COUNCIL SUPPLEMENTARY ASSESSMENT REPORT

Panel Reference	2017SNH072
DA Number	DA326/17
LGA	North Sydney
Proposed Development	Construction of 5-storey health facility with lower ground level parking for 11 cars, demolition of ancillary buildings to permit vehicle driveway, earthworks, associated landscaping, conservation works to Carpenter House
Street Address	25 Shirley Road, Wollstonecraft
Applicant/Owner	Tresillian Family Care Centres
Date of DA lodgement	18 September 2017
Number of Submissions	Original DA 131; Amended DA 103; Total Unique Submissions 189
Recommendation	Refusal
Regional Development Criteria (Schedule 7 of the SEPP (State and Regional Development) 2011	Private infrastructure and community facilities over \$5 million
List of all relevant s4.15(1)(a) matters	<ul style="list-style-type: none"> • North Sydney Local Environmental Plan 2013 • Rural Fires Act 1997 • State Environmental Planning Policy (Infrastructure) 2007 • State Environmental Planning Policy No. 55 – Contaminated Lands • Sydney Regional Environmental Plan (Sydney Harbour Catchment) 2005 • Integrated Development • North Sydney Development Control Plan 2013

SUPPLEMENTARY REPORT

ADDRESS/WARD: 25 Shirley

Figure 1 – Amended building footprint, original building footprint shown dotted blue.

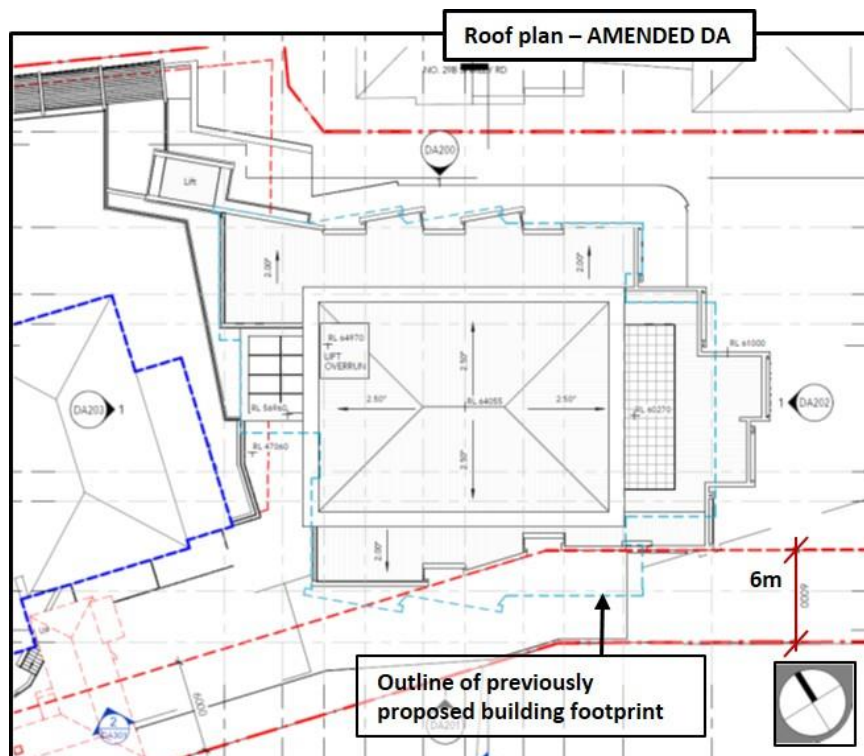
Extracts from the amended drawings are provided in **Figure 1**, showing the outline of the originally proposed building envelope, in plan and elevation, relative to the amended development.

Figure 17 – Proposed building height (8.5m line applicable to adjoining zones)

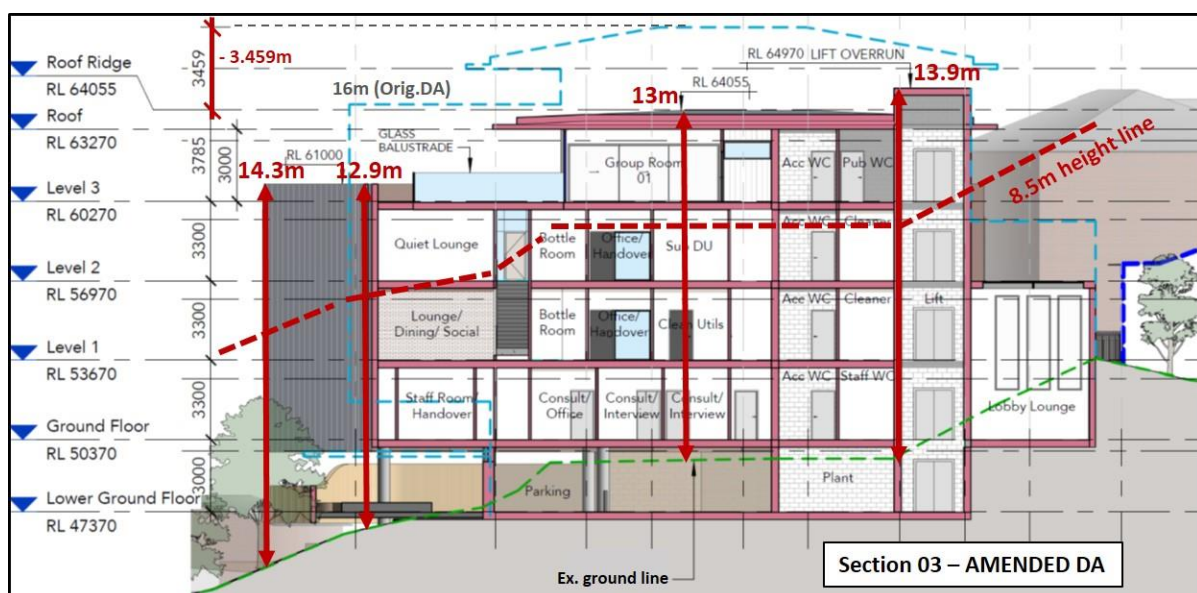
The height of the amended development above existing ground levels is measured at 14.3m at the rear parapet, 12.9m at the main parapet, 13m to the top of roof, and 13.9m at the lift overrun as indicated in Figure 17. The maximum building height occurs at the eastern elevation of the building where existing site levels fall away steeply towards the rear.

Figure 18 – Building section showing existing ground levels.

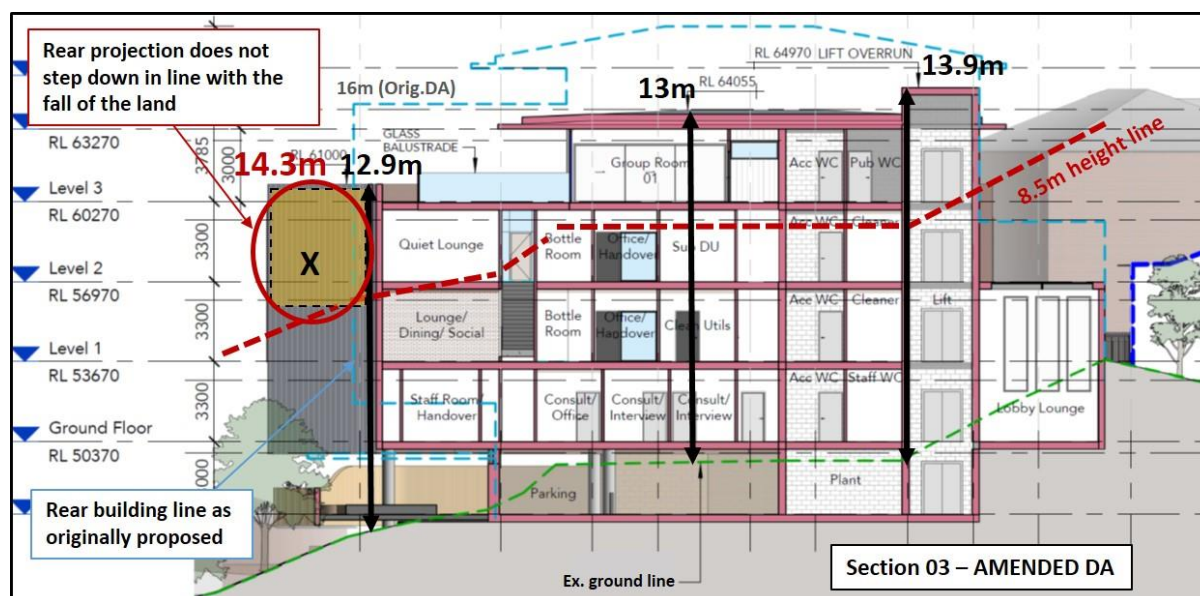
The centre rearmost portion of the building, extends the building east beyond the rear building line as originally proposed. This element has height of 14.3m to the parapet (**Figure 18**). Due to the impacts on view loss and the relationship with internal areas it is this part of the building is not supported.

The rearmost extension of the building (beyond the original rear building line indicated by the light dashed blue line in **Figure 18**) contravenes para. (a) of LEP Clause 4.3 and DCP character statement, Section C10.10.6 P4, which identifies as characteristic “*reduced height and scale to rear*”. These non-compliances result in overbearing and other amenity impacts on adjoining dwellings.

Figure 22 – Proposed height compared to buildings on adjoining properties. Original proposal shown dotted blue as indicated

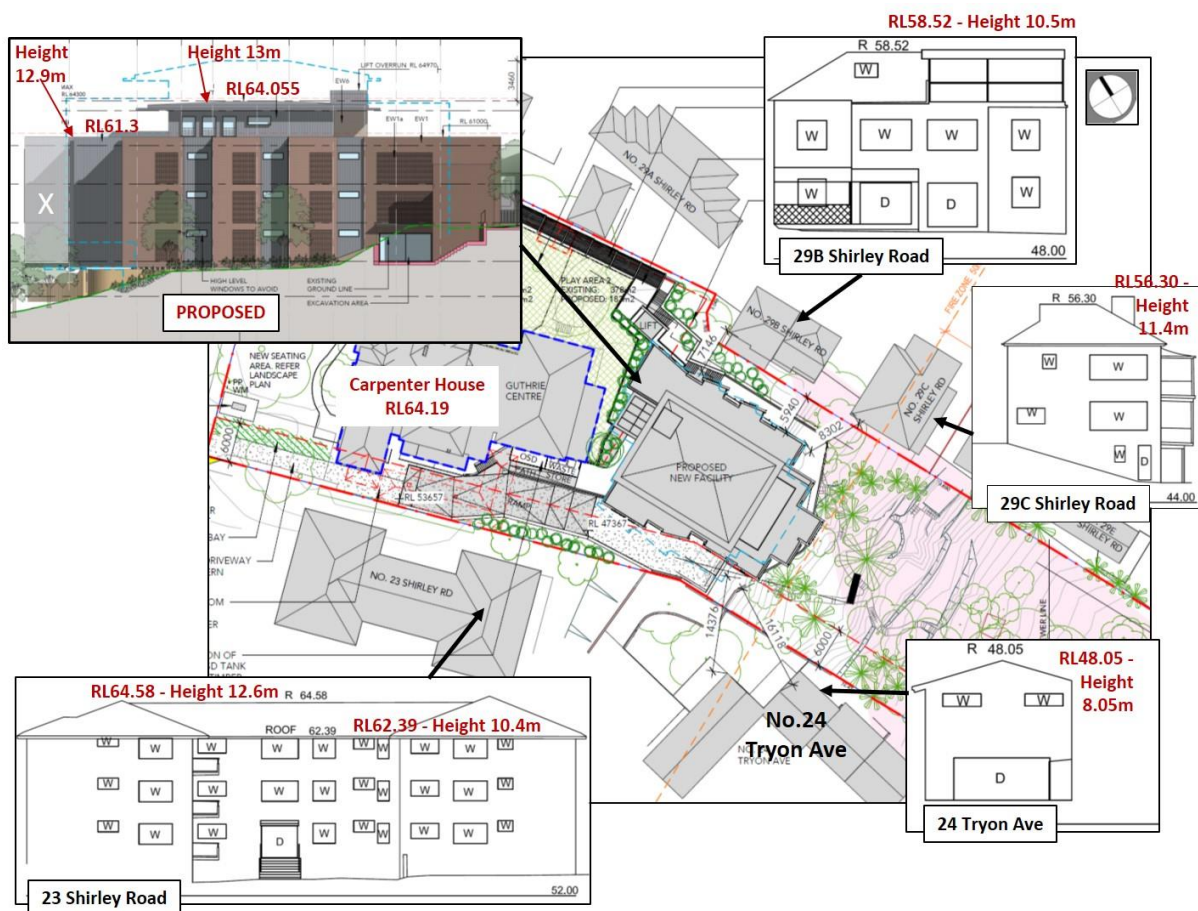
The proposed building heights of 12.9m and 13m at the main parapet and roof level, respectively, are similar to the height of the residential flat building at No.23 Shirley Road adjoining to the southwest but is 5.55m above the flat building at No.29B Shirley Road (**Figure 22**).

Figure 23 – Sight lines from No's. 29A & 29B Shirley Road across the site to Sydney harbour

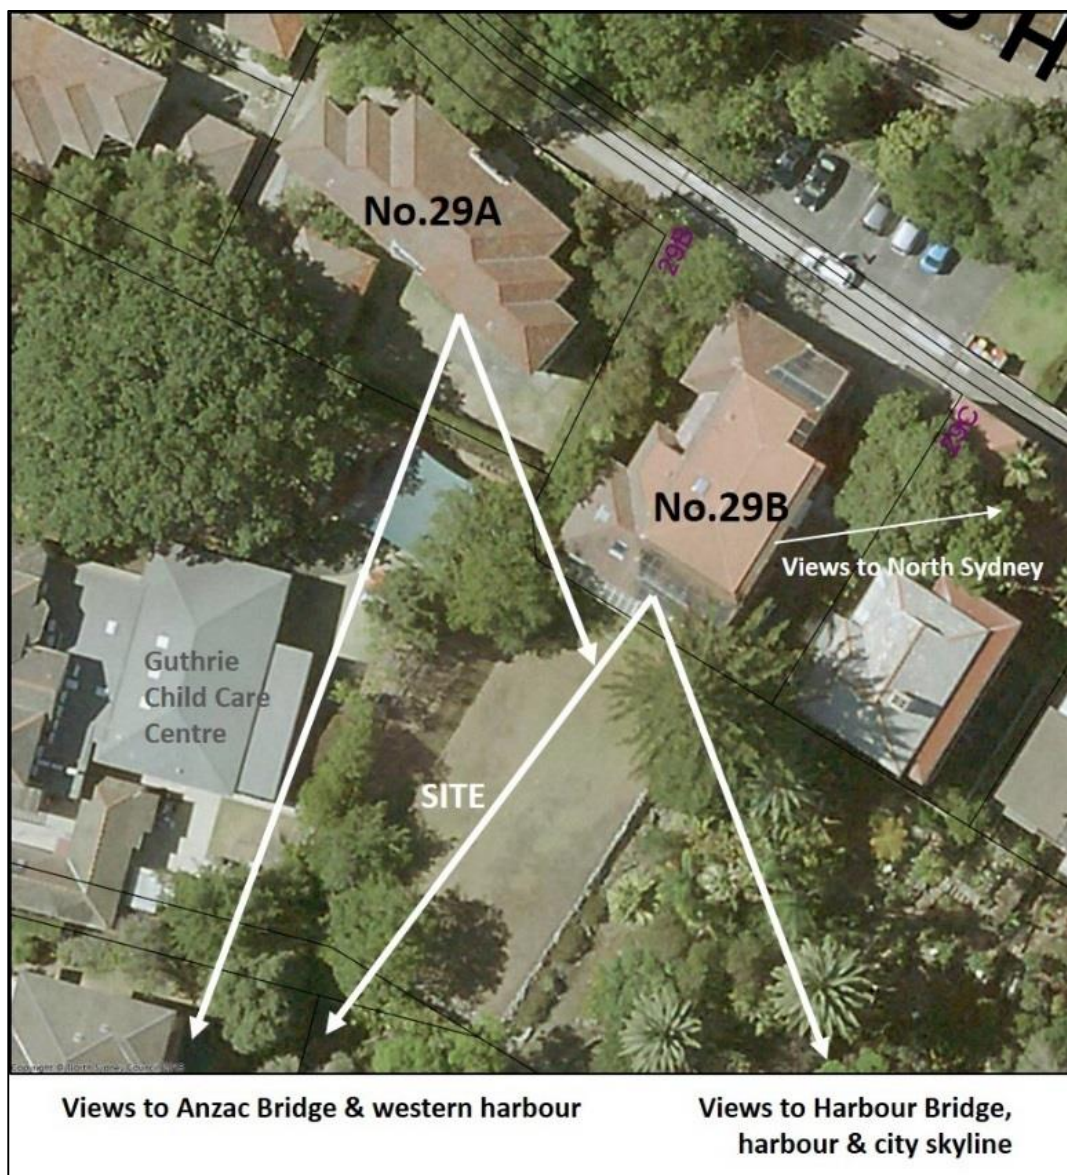
The most affected views are from the living and sun rooms, bedrooms and kitchens of adjoining apartment units located at No's. 29A & 29B Shirley Road (Figure 23).

Figure 24: View impact analysis for Unit 3 29B Shirley Road

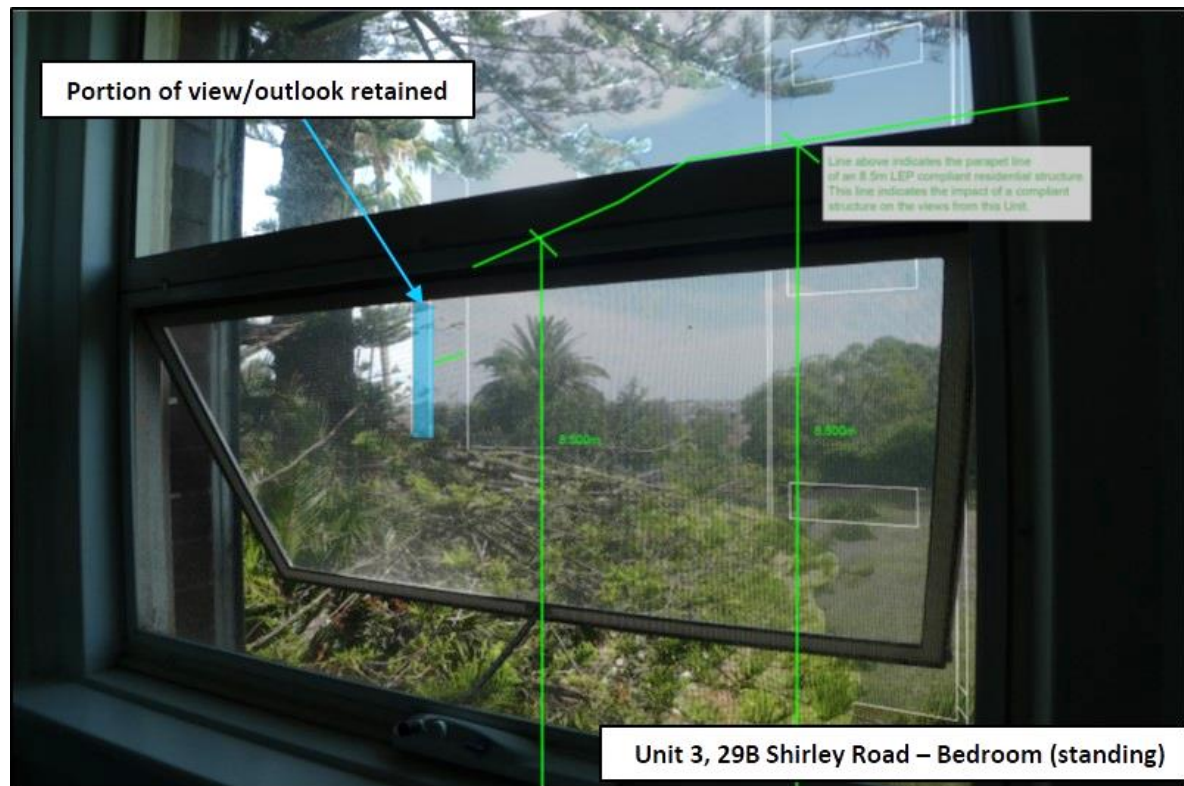
The development will result in the loss of views to part of the Anzac Bridge (including both pylons and cables) as viewed in a standing position in the living room, and loss of district views from the main bedroom. The views are obtained across the side boundaries of the subject site and above vegetation.

The view impact on Unit 3, 29B Shirley Road is assessed to be **devastating** given that the views lost are from the living/sunroom and main bedroom, and they are the only and primary outlook of the dwelling. There is very little left by way of view outlook from the primary living areas of this unit as a result of the amended development.

Figure 29: Existing & proposed shadows 3D 10am 21 June

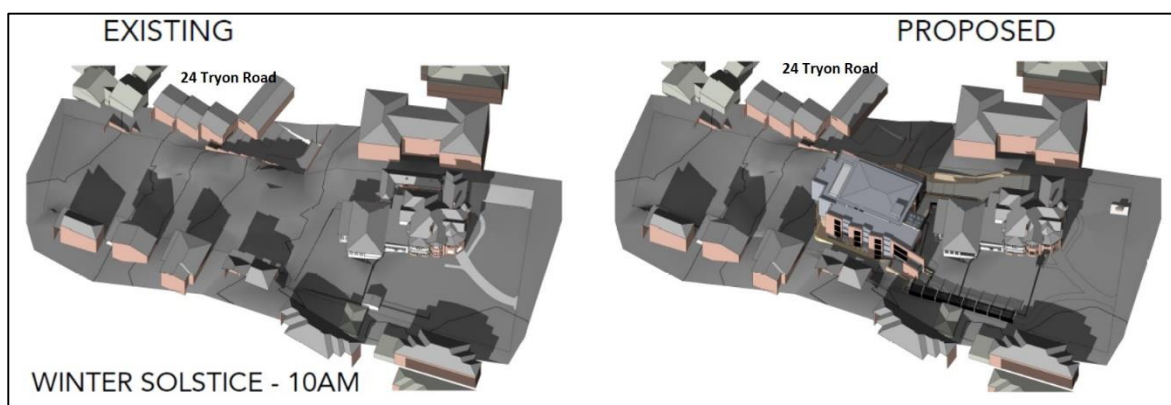
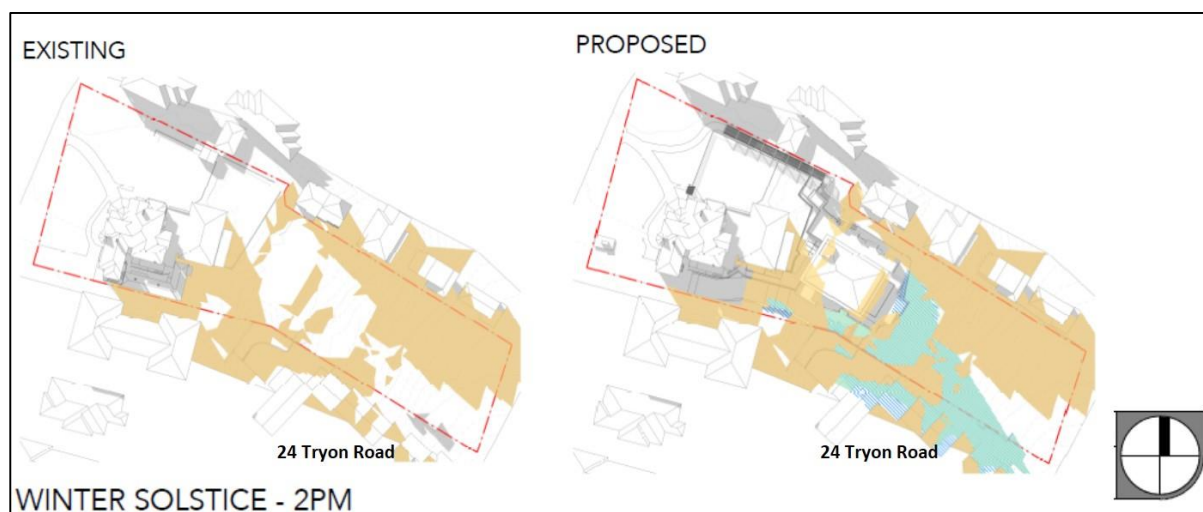
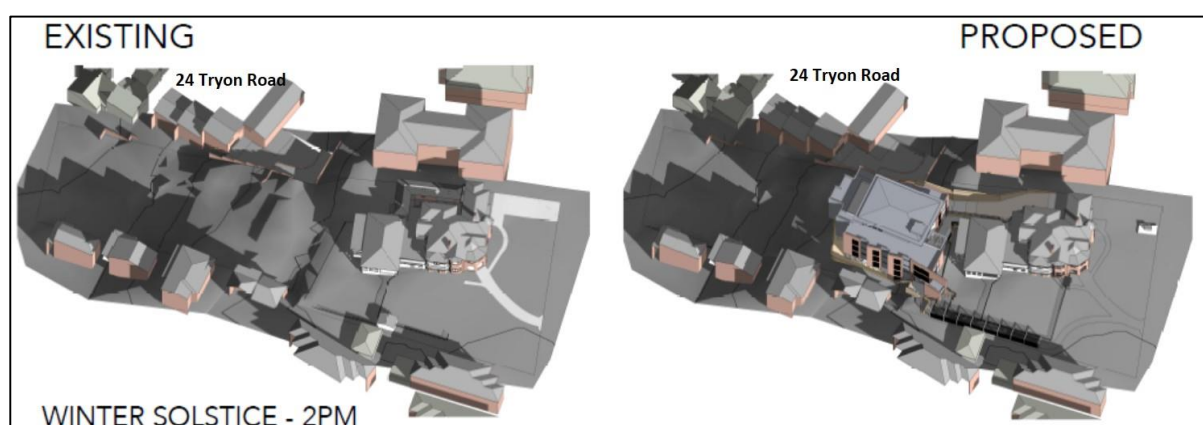
The original and amended development proposals do not satisfy the minimum requirements to provide a minimum 3 hours solar access to the private open space and windows of adjoining residential premises during midwinter. Existing and proposed shadow diagrams detailing the likely impacts arising from the original proposal are provided in **Attachment 1**. A summary of the most significant impacts can be noted in the following extracts from the submitted amended shadow diagrams detailing the 10pm & 2pm impacts during midwinter (Figures 28 to 31).

The extent of impacts arising from the amended proposal is assessed to be generally comparable to the impacts arising from the original proposal. The previous conclusions on the extent of impacts on neighbouring residences remain the same, identified in the following table.

Figure 33 - Protection measures for Tree T35

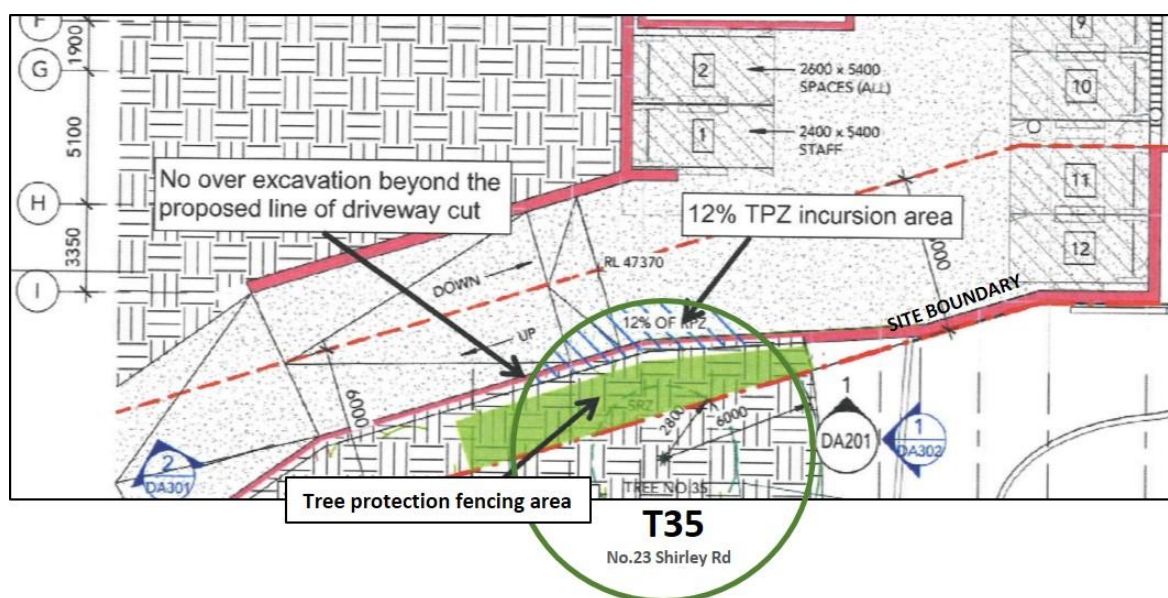
The amended driveway has been designed to allow for retention of an 8m high NZ Christmas Tree growing in the south-adjoining property at No.23 Shirley Road, adjacent to the common boundary (**Figure 33**). This tree is identified as T35 in the submitted Arboricultural Addendum Report by Rain Tree Consulting dated 6 August 2018. The arborist report finds that the proposed development would have negligible impact on the tree, subject to implementation of the recommended tree protection measures achievable (via **condition**).
